TERRY & HOWELL

RECOMMENDATION MEETING

AUGUST 18, 2015 | DPD #3017451 | 14-018

A2.2 ROOFTOP MECHANICAL EQUIPMENT

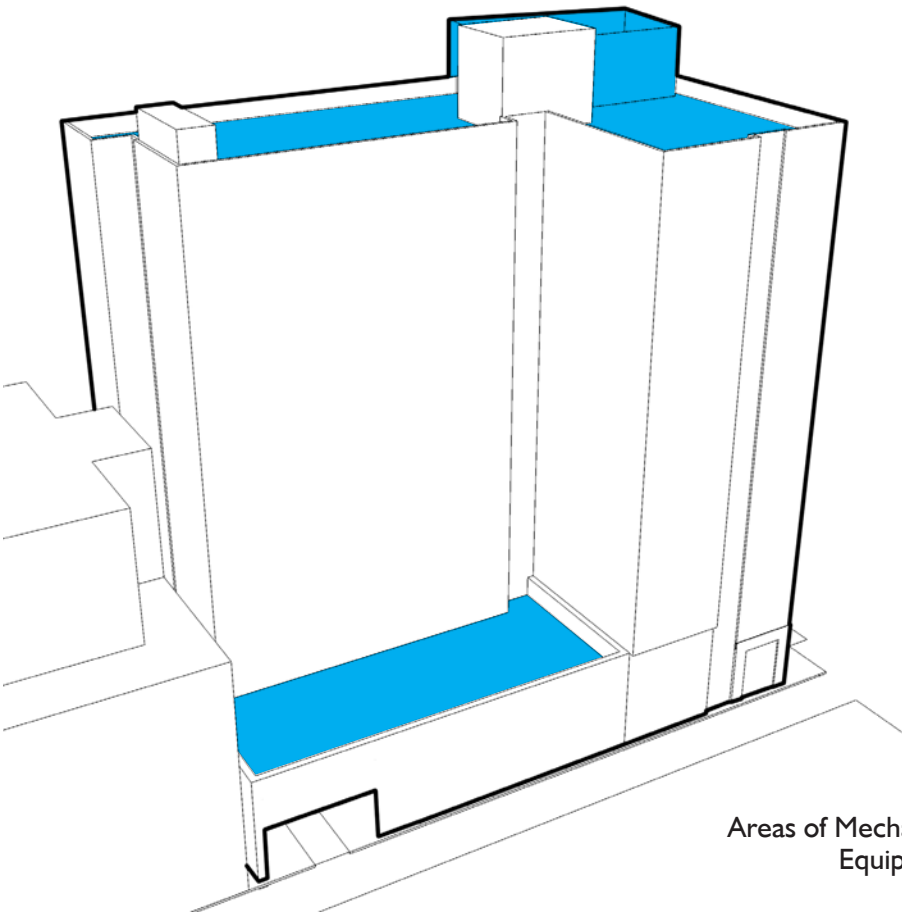
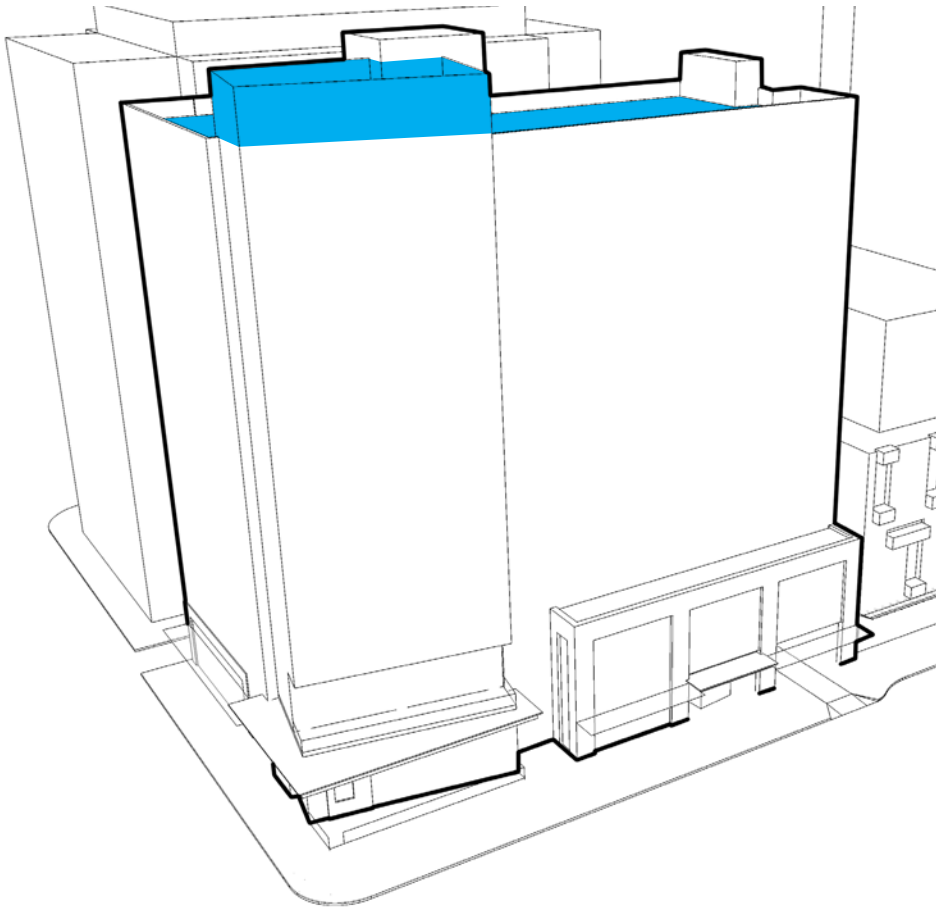
Responding to the public comment urging a well-designed roof, the Board noted that neighbors would look down on the mechanical systems. This presented sufficient reason to create an attractive enclosure housing the HVAC and other mechanical equipment

Major mechanical equipment will be housed in the crown of the canted glass corner element, with required venting. Other mechanical penetrations and equipment, on the lower and upper roofs, will be located sensitively and screened where possible to provide attractive roofscapes

High quality materials, used elsewhere in the building will be used the screen major mechanical elements on all sides

Plans show preliminary mechanical placement, coordination is ongoing. Major equipment to be placed within the crown element, other equipment must be placed on leg roofs for efficiency

B4.2 COHERENT INTERIOR / EXTERIOR DESIGN

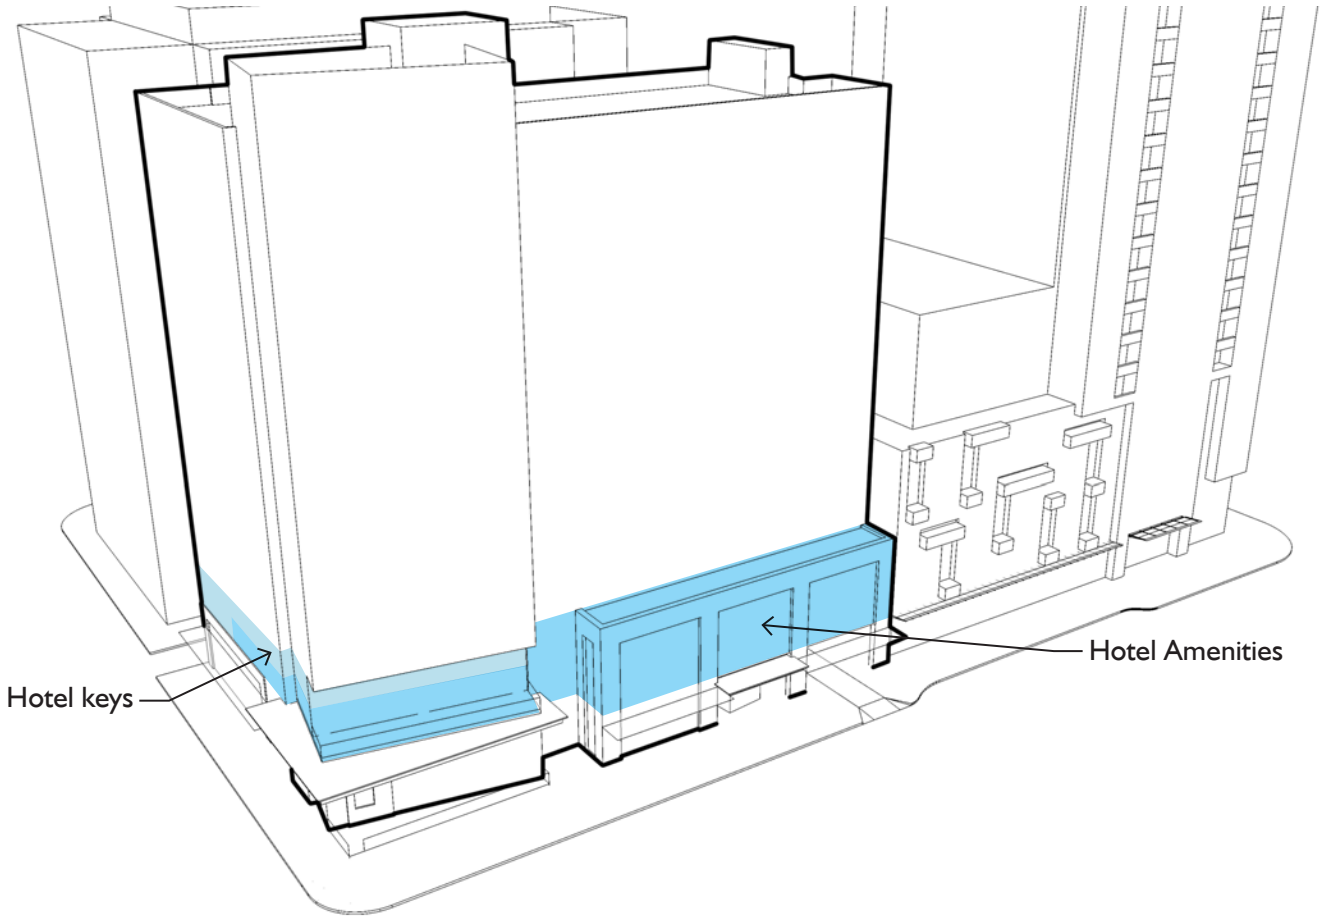
The frames delineating the podium appear ponderous and inelegant to the pedestrian's scale. Covering the upper level parking garage apertures with green screen is an insufficient response to an important design issue. The Board recommended that the architect study the elegant solution of an above grade parking garage integrated within a podium proposed at Western and University (DPD# 3014451)

The Board prefers an active second floor as programmed in the alternative scheme. The lack of an above-grade garage would not justify a curb-cut on Terry Ave as the two elements are unrelated. (Staff note: the 220-230 parking spaces represent a significantly greater number of spaces than a downtown hotel (even with a restaurant and a small retail space) typically warrants. The Land Use Code requires one space per four hotel rooms.)

There is no longer above-grade parking, all parking is to be provided below-grade. Parking count is 149 stalls, or a 0.48 parking ratio. The L2 and L3 spaces are now Hotel Amenities (meeting spaces and prefunction, fitness) and hotel keys

C2.1 MODULATION OF FACADES

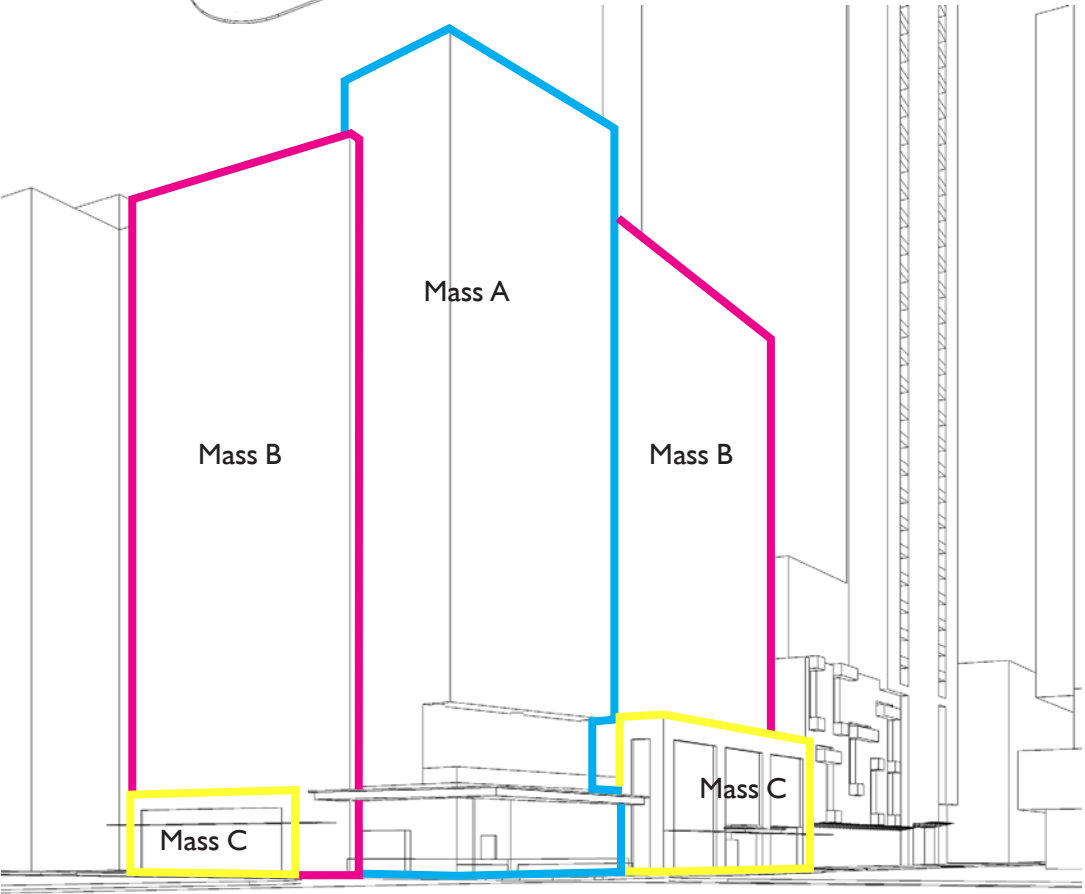
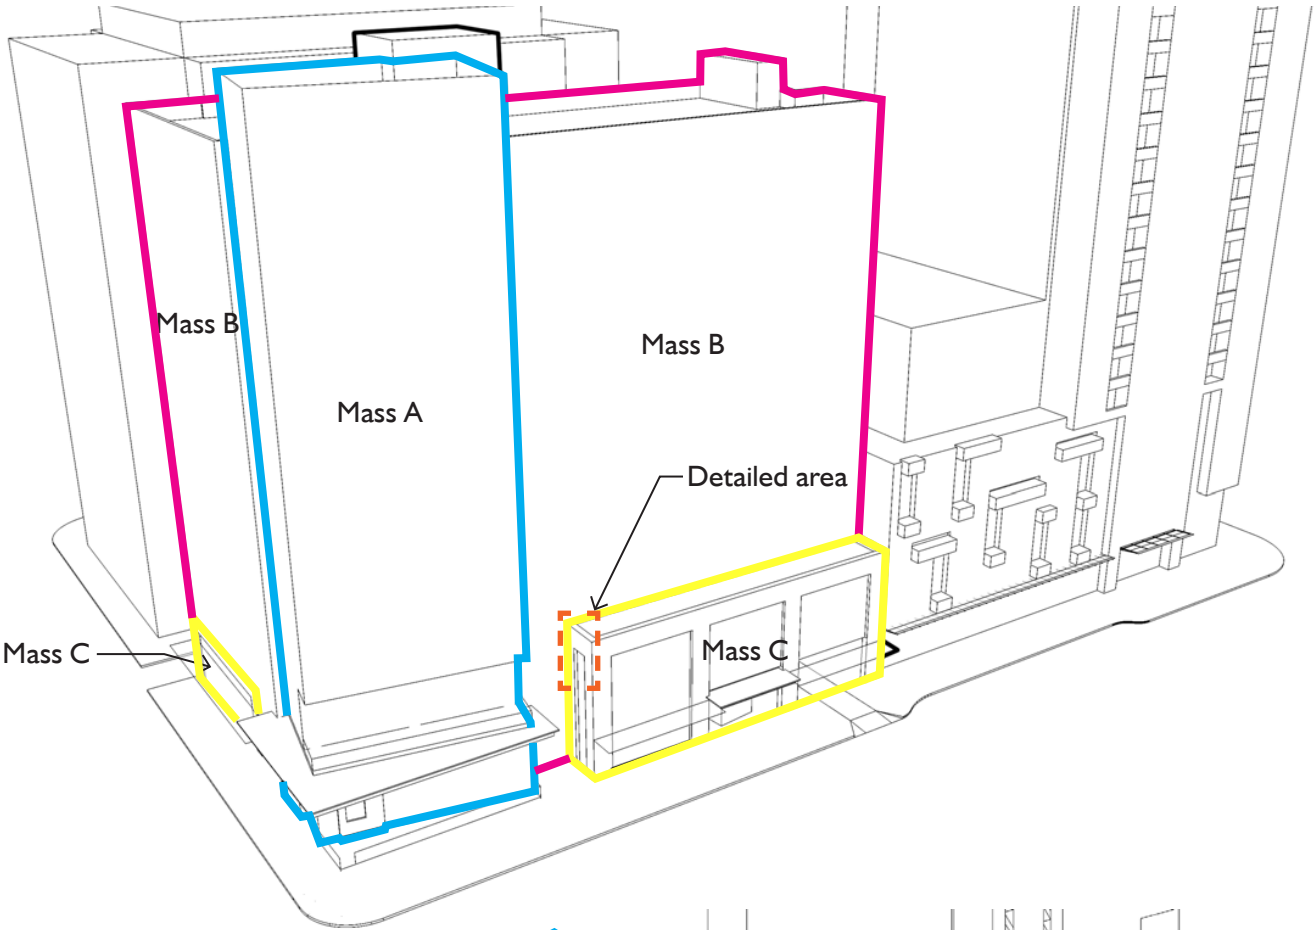
See discussion of the corner tower in Guidance B4.I

The primary facades are broken down into different scales and materials, to create a unified, yet visually interesting building. Mass A is glassy, Mass B has punched openings, and Mass C relates to the pedestrian with a warm and durable stone material

See further discussion of the corner tower in Response B4.I and Departures

C5.1 OVERHEAD WEATHER PROTECTION

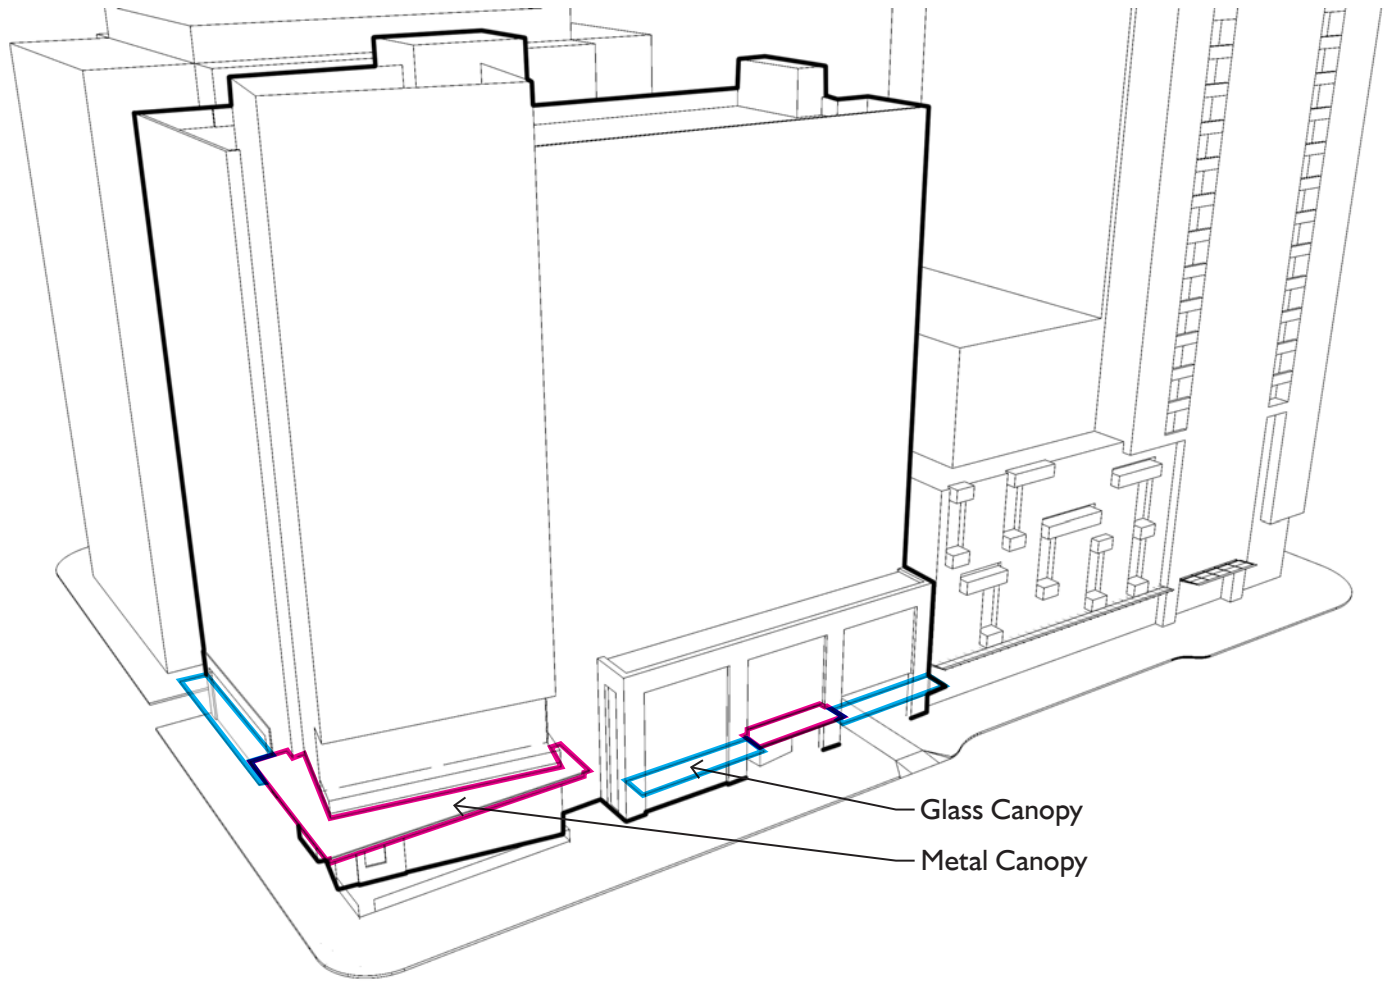
The Board requested continuous canopies along the two major facades. Give better shape and definition to the canopy at the corner volume. Its outer edge doesn't necessarily need to run parallel to the two planes of the tower

Continuous canopies are provided along the two major facades. The pedestrian entry along Terry Ave, and the canted corner have special canopies which announce entry, integrating lighting and signage

C6.2 ALLEY PARKING ACCESS

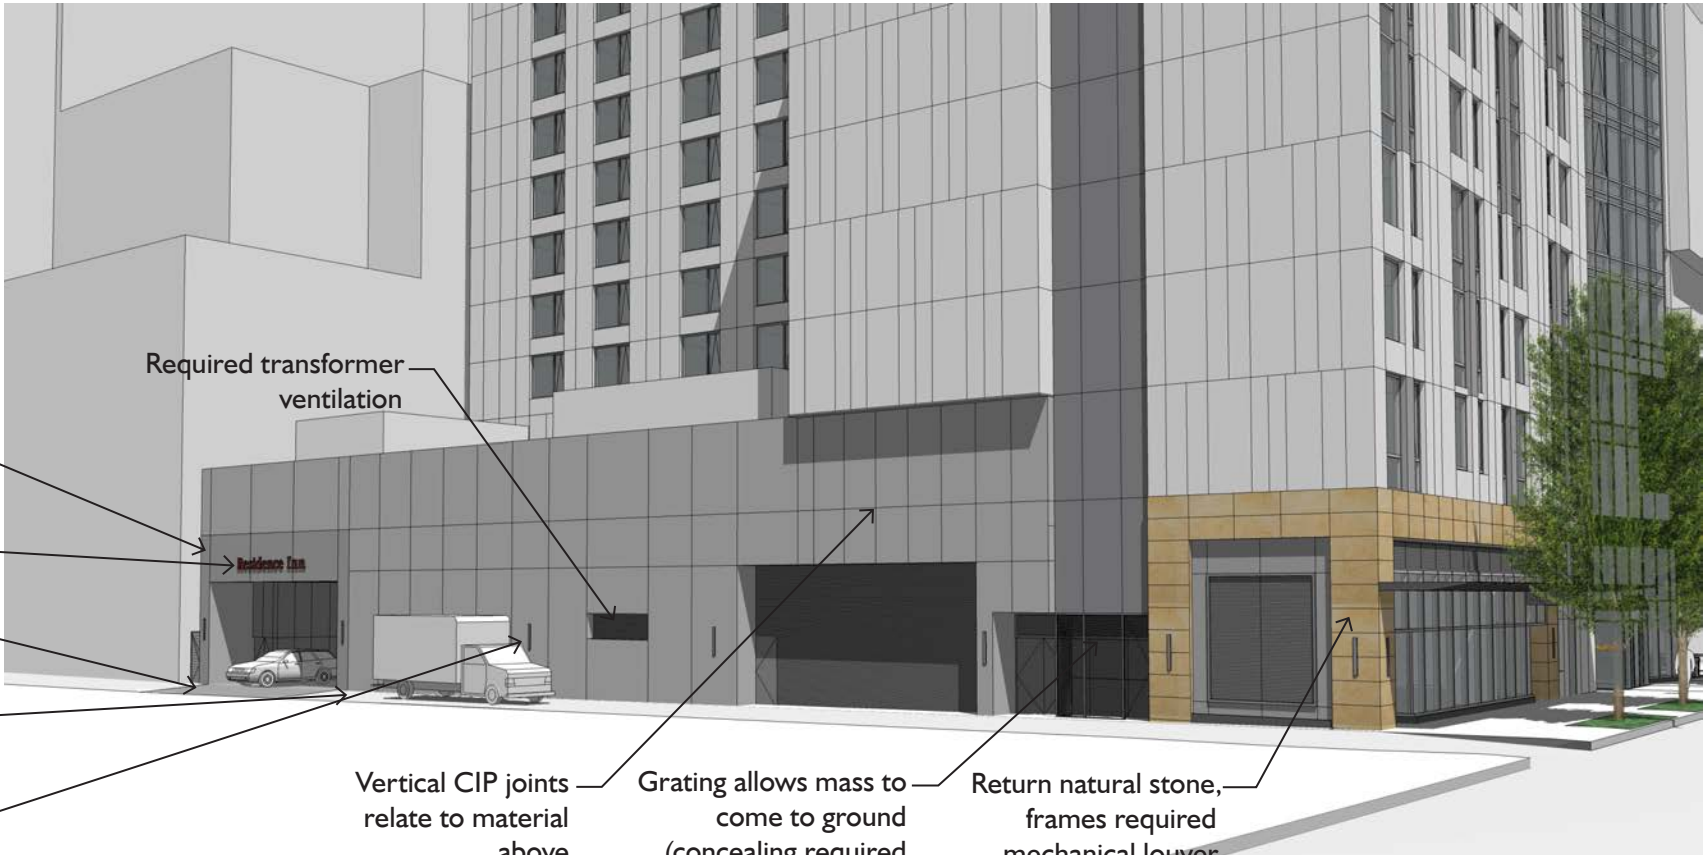
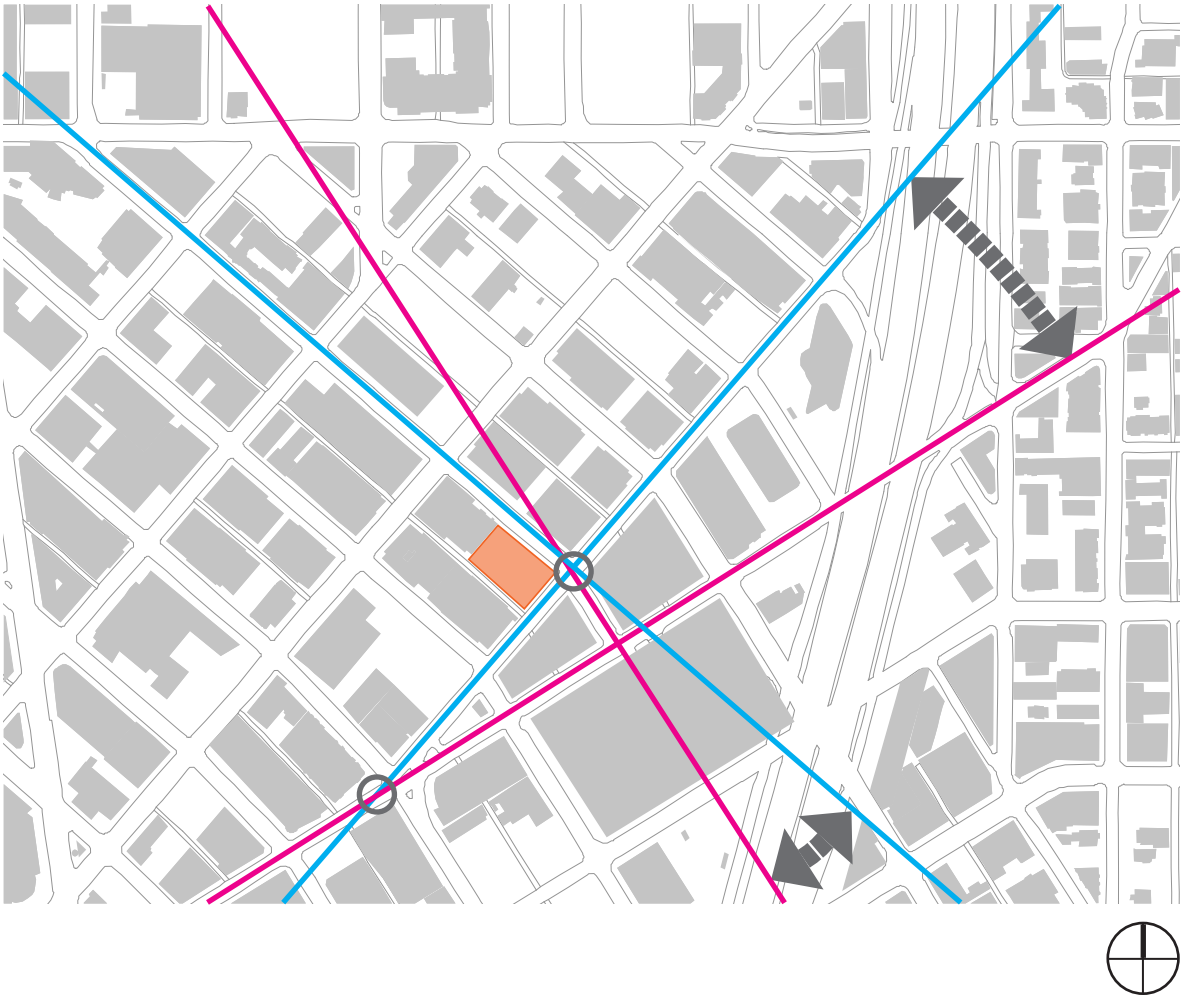
The alley should be more thoroughly explored as an entry approach for drop-off for the hotel. The porte-cochere could sit parallel to the alley. Enhancements to the alley, with pavers, festival and other types of lighting and an attractive facade, could produce a strong and convincing sense of place in the spirit of Hotel 1000 at First Ave and Madison and The Olivian (apartment building) at Eighth Ave and Olive Way

The design team studied options for dropoff locations, no other option was feasible or acceptable to the client, as it impacted the mechanical needs, function and/or arrival sequence of the hotel. The site has two one-way streets fronting it, and Howell is a major transit street. Having vehicles enter and exit off Howell or the alley would severely overload the alley, which is already heavily trafficked

The curb cut for this hotel has been approved via Directors Decision, one-way, 10' wide, and documented in this package

Care has been taken with the alley facade, including extending the retail language into the alley, utilizing the porte cochere paving pattern (pending SDOT approval) and providing the same pedestrian-scaled lighting as the street facades
